King Street Pump Station Improvements (Volume I) & ASR Lime System Improvements (Volume II) - RFCSP
Solicitation Number: CO-00670
Job No.: 20-6002 and 22-8603

ADDENDUM 2
October 12, 2023

C WELL NO 5 ELEVATION
SCALE: 3/8" = 1'-0"

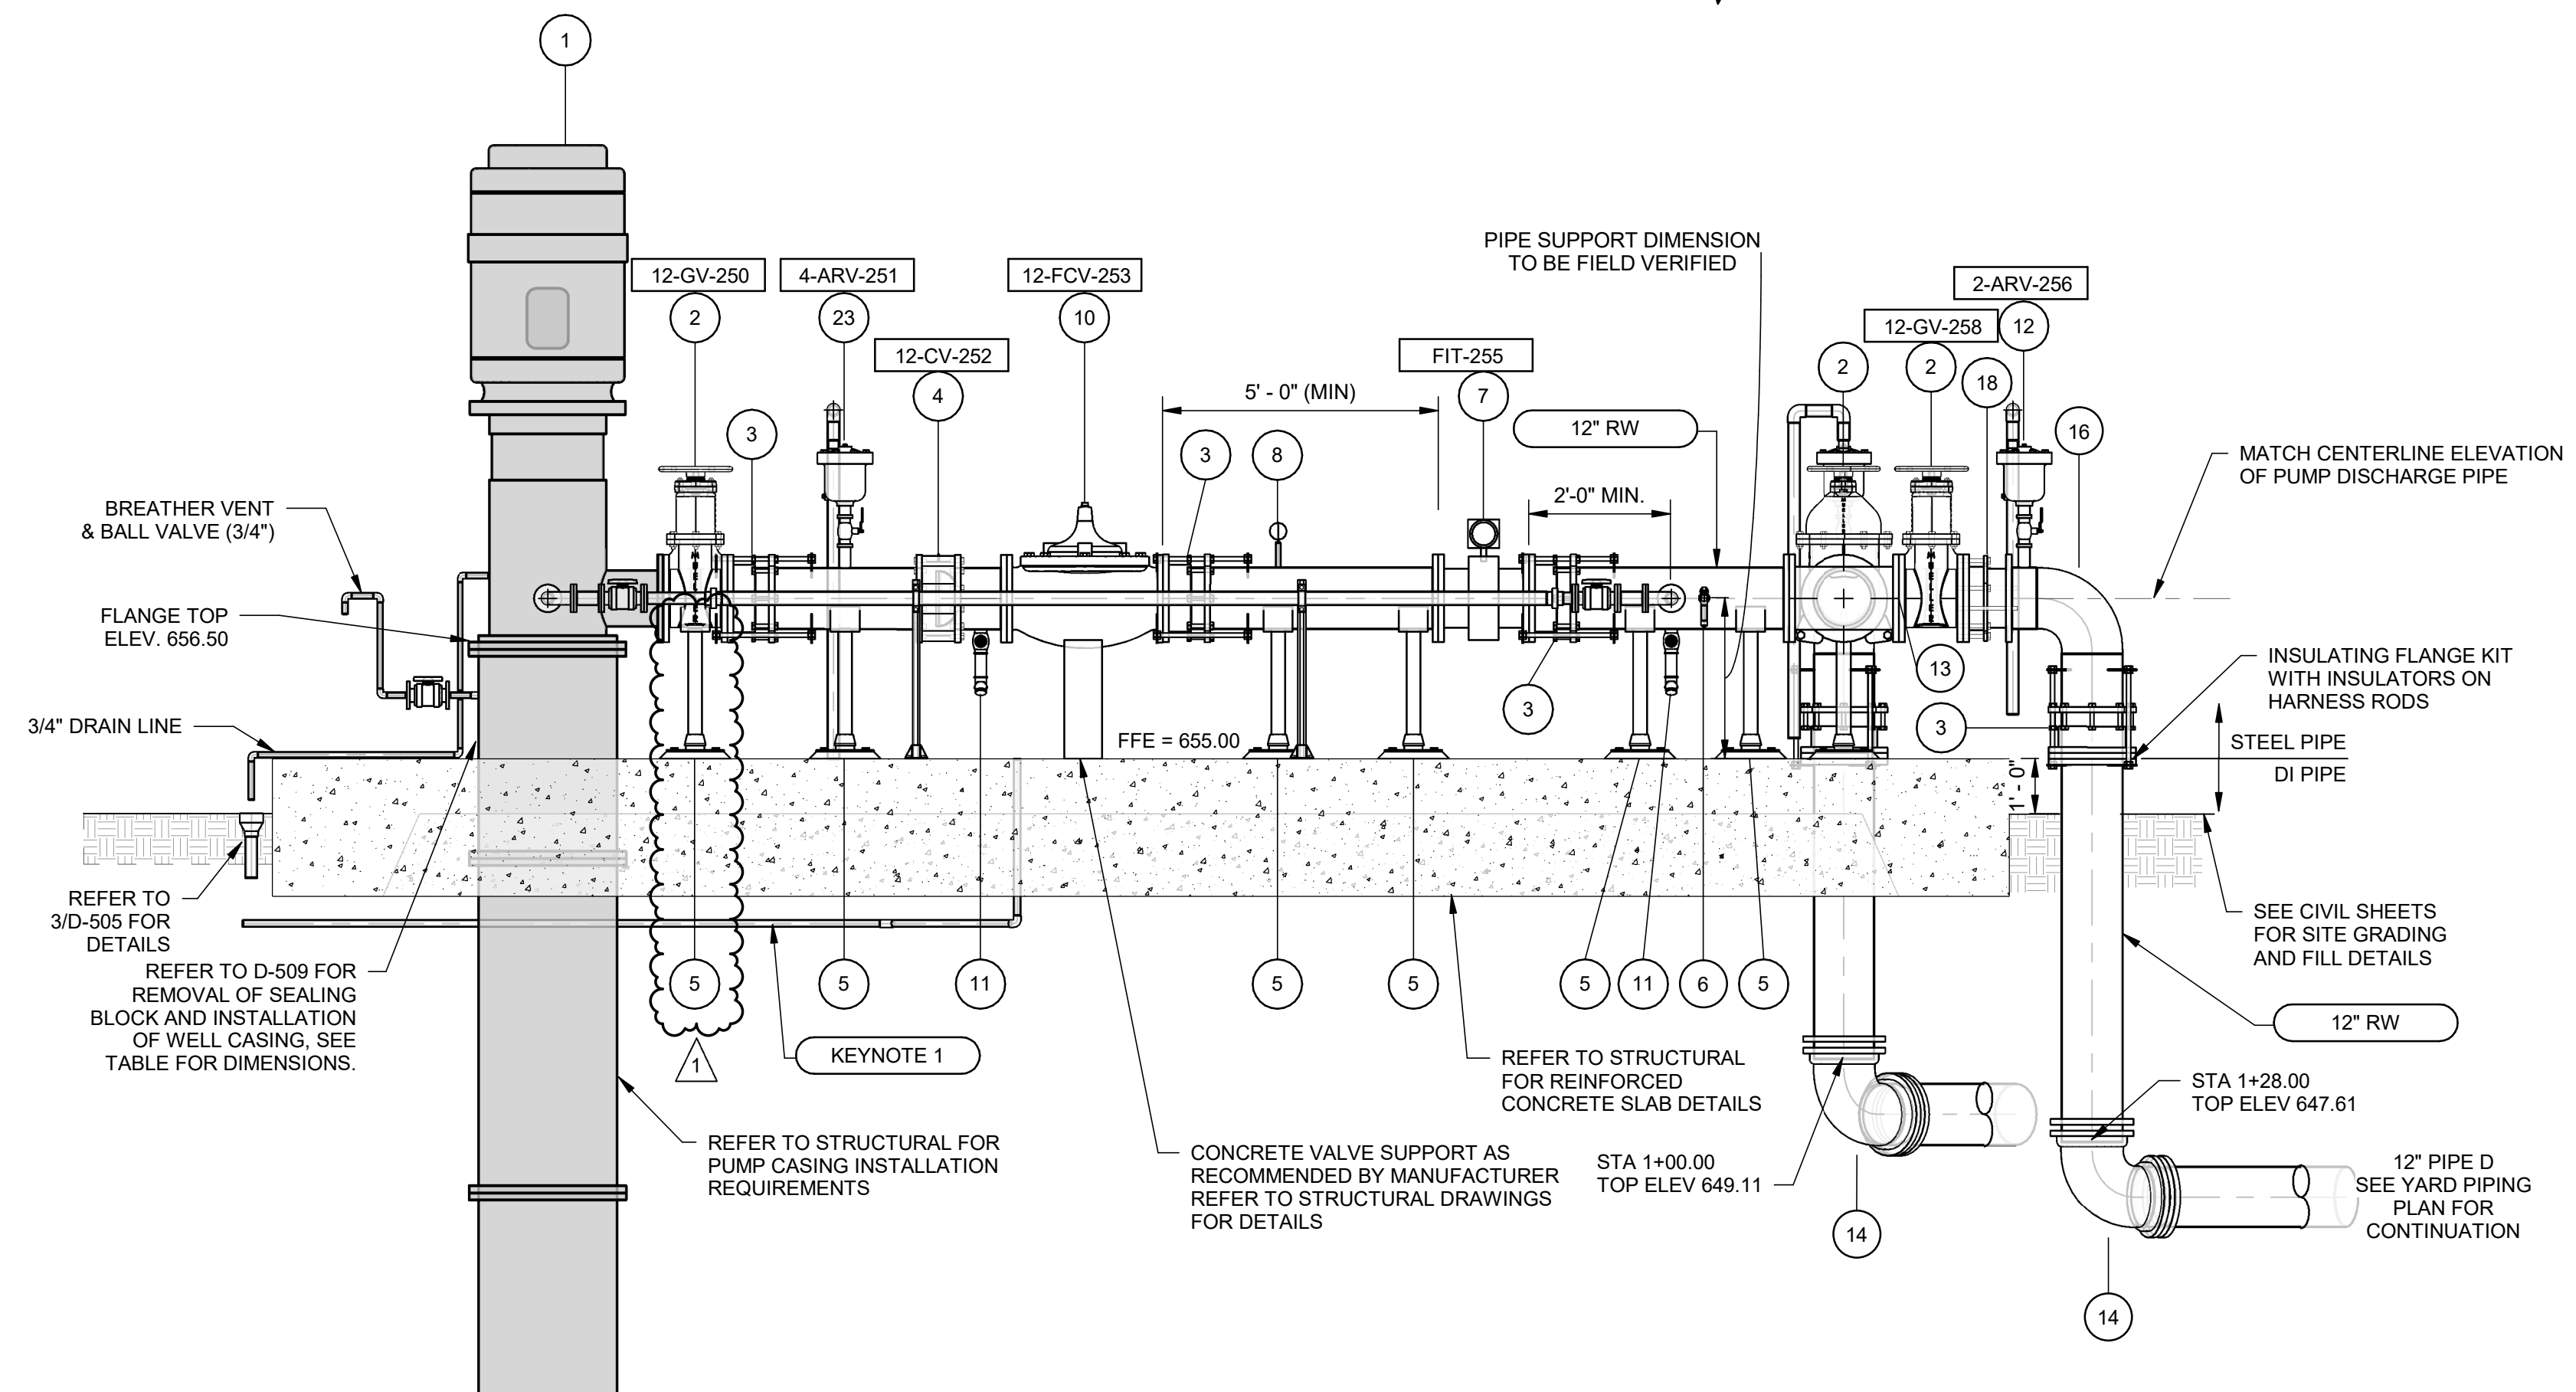
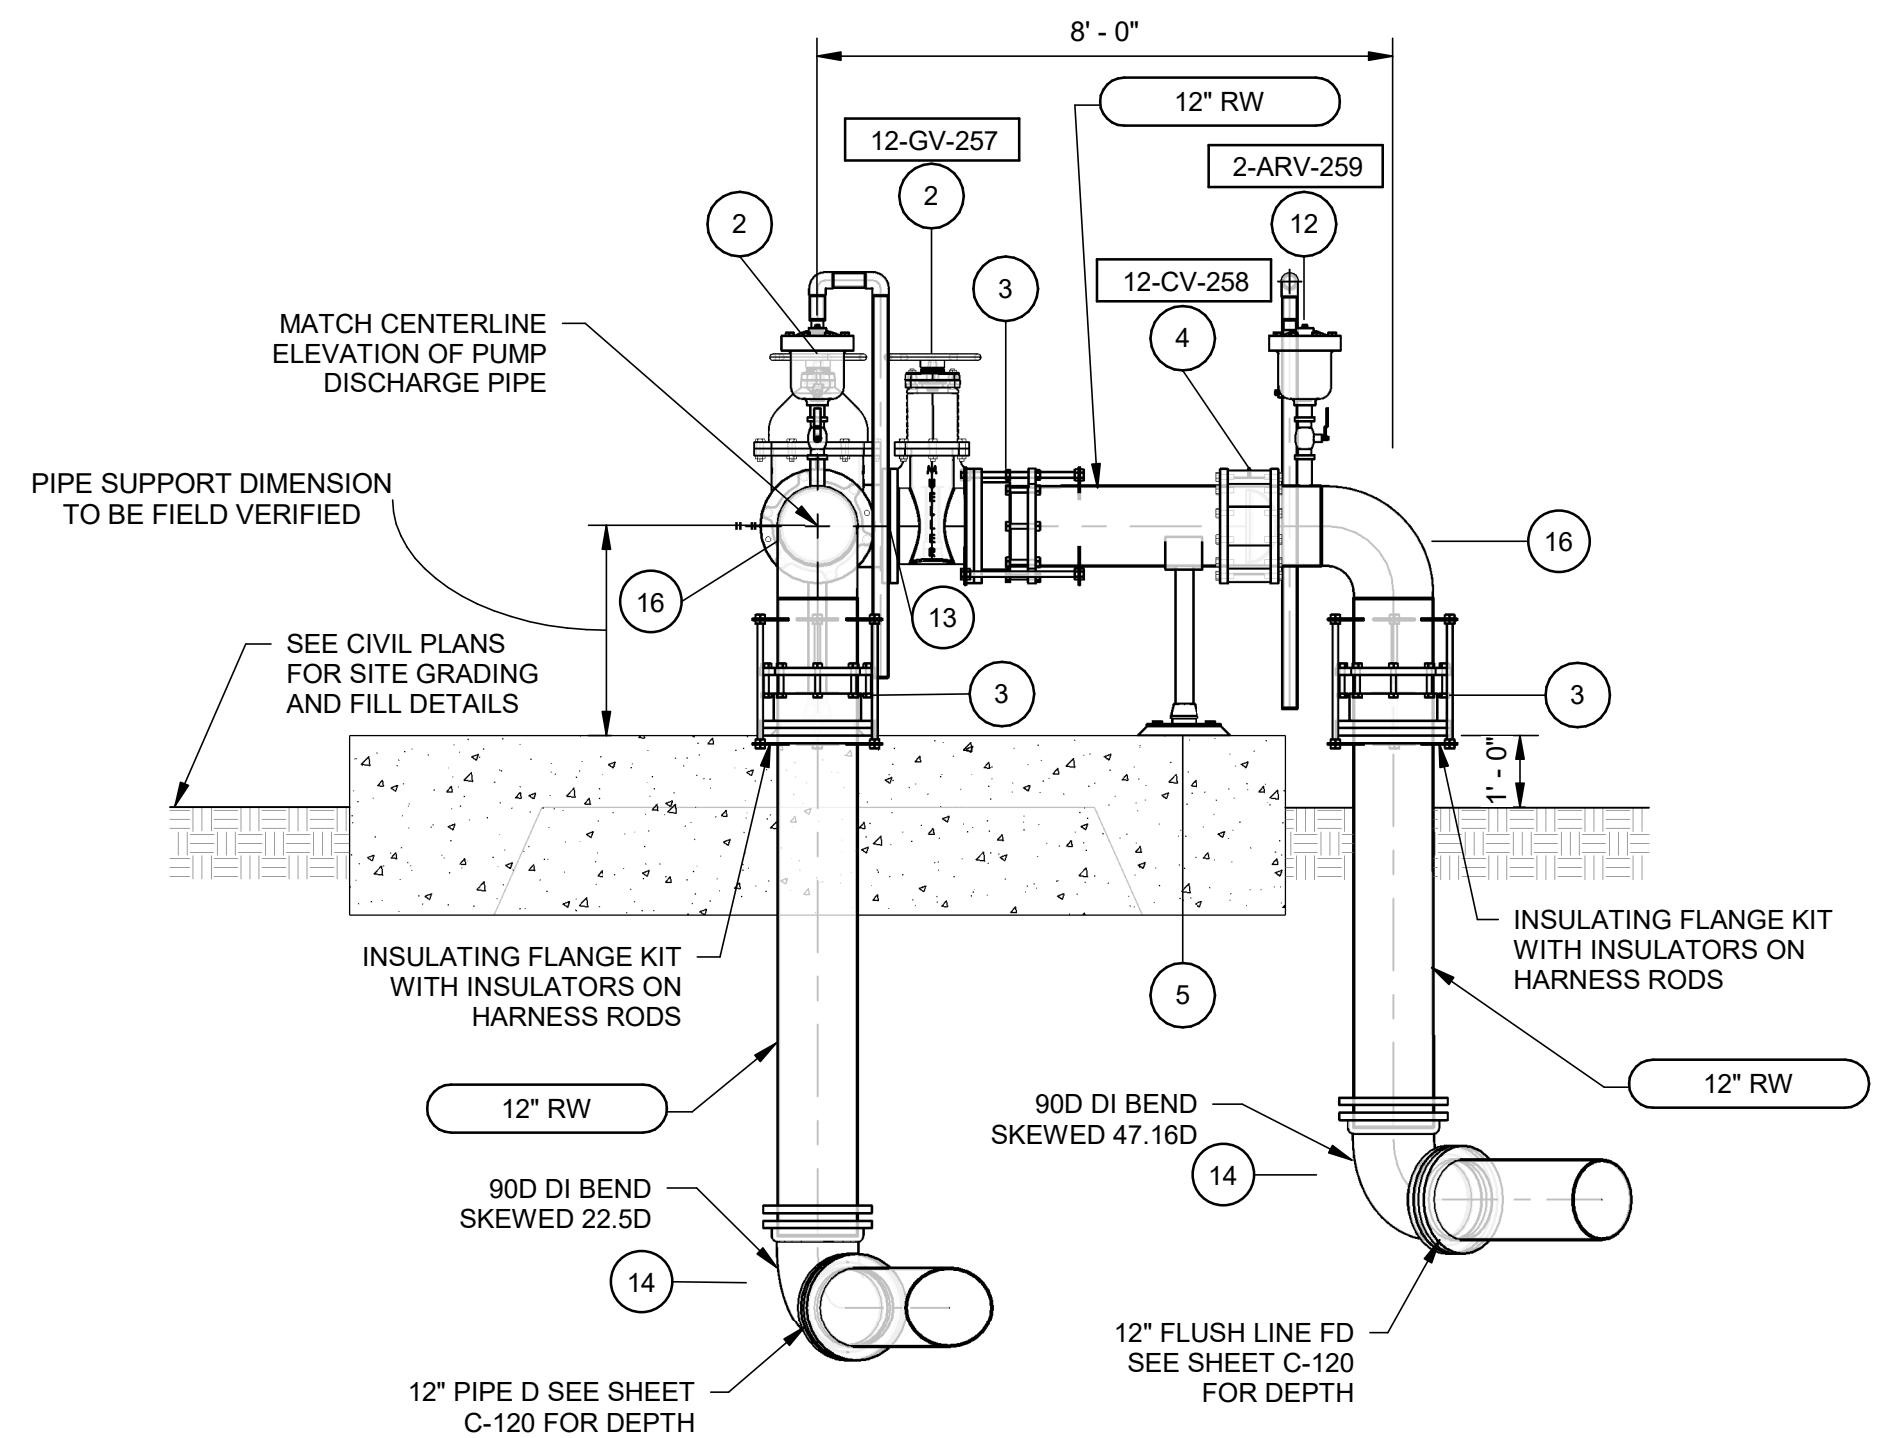
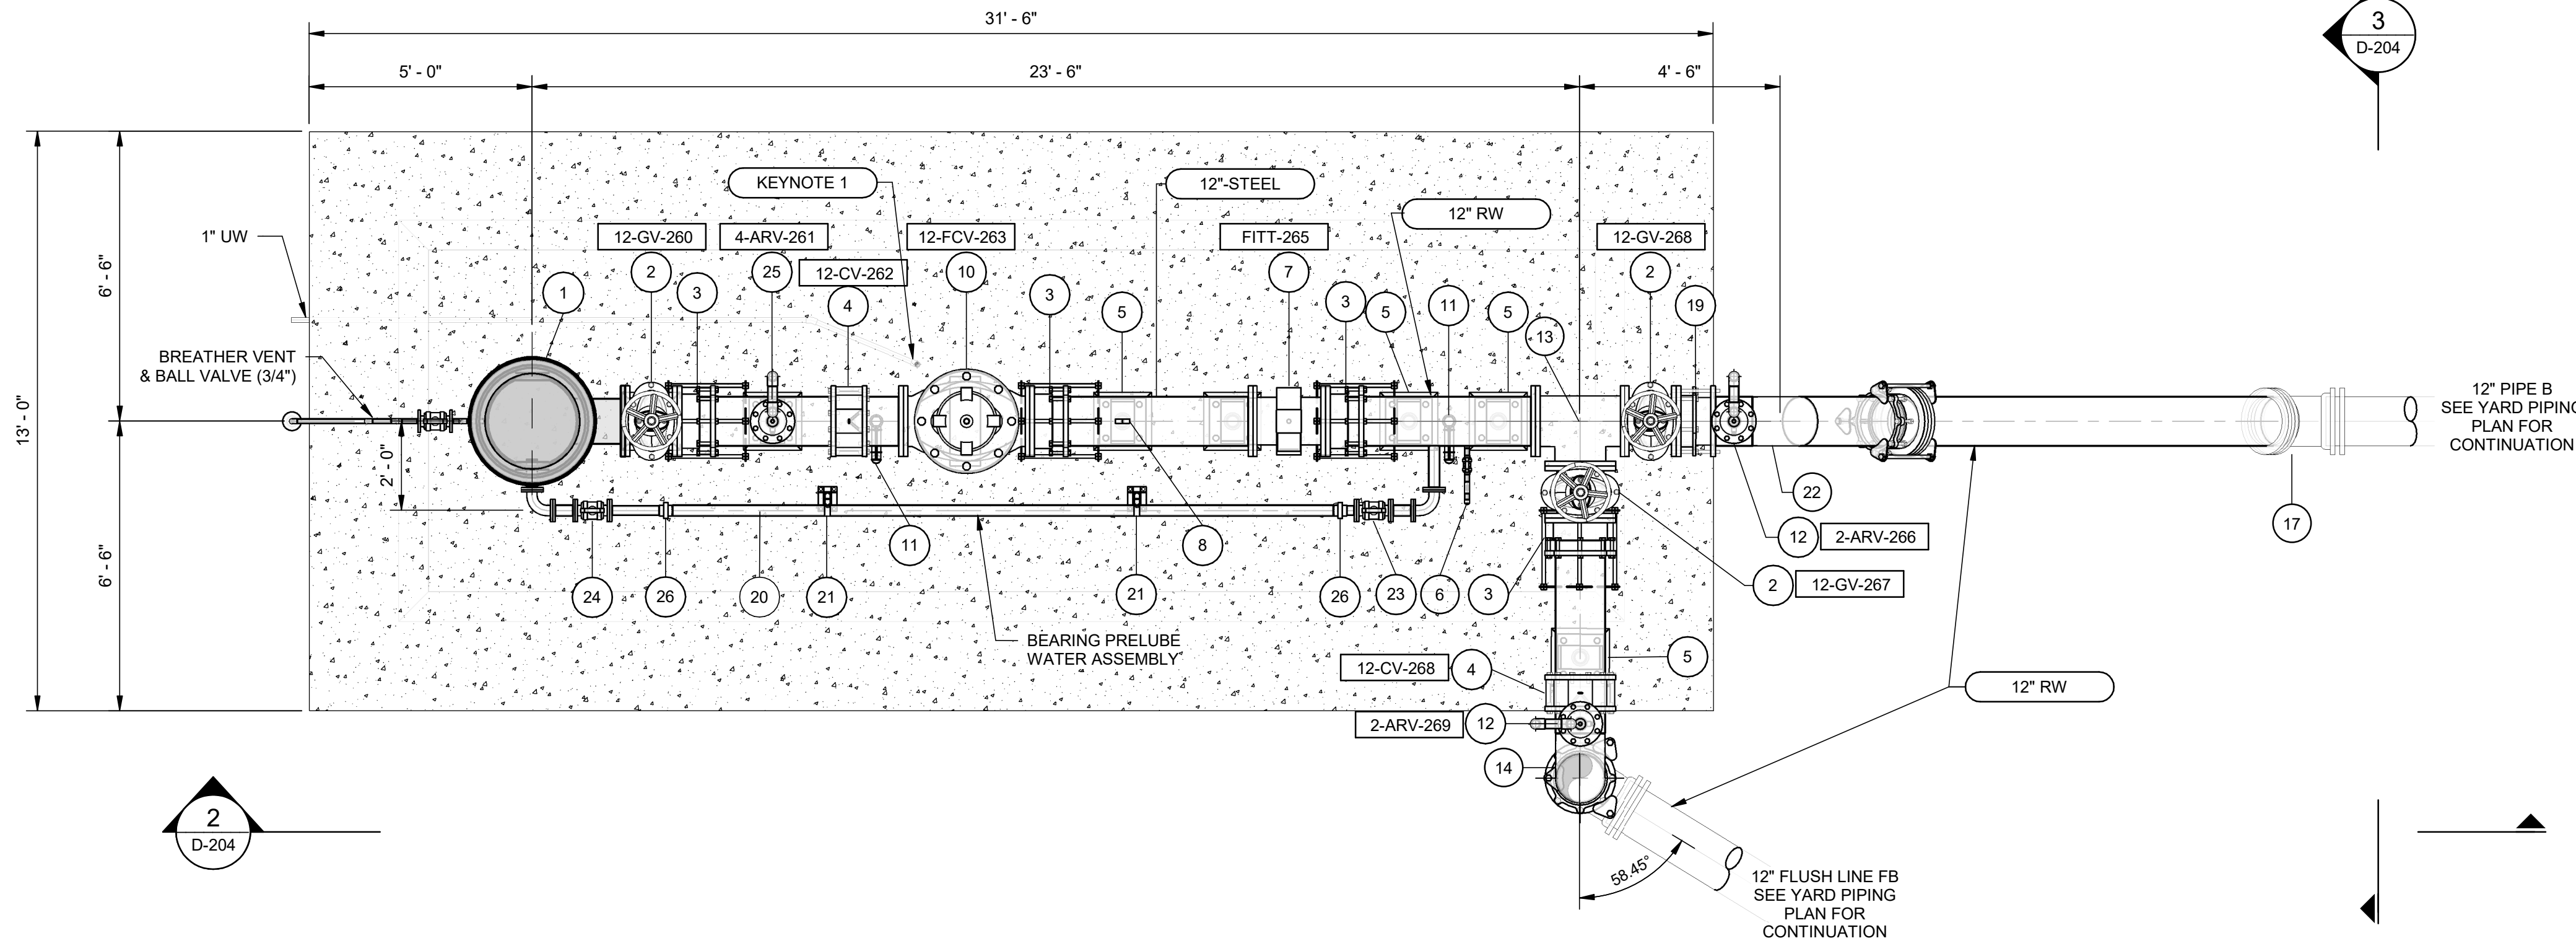
- 49. Question: Contract Drawings, Sheet D-203/204, add permanent pipe support under 12" gate valve that completely supports weight. Pump discharge should not be anchor point for any of discharge piping.**

Response: Refer to "Changes to the Plans" section item No. 3, item No. 4, item No. 5, and item No. 6 in this addendum. Pipe support added to drawings.
- 50. Question: Contract Drawings, Sheet D-203/204, add housekeeping pad/foundation around well casing pipe extended above finish floor. Surface plate assembly will be welded to well casing after installation/leveling. Grout to be poured up to bottom surface of top plate of the surface plate assembly.**
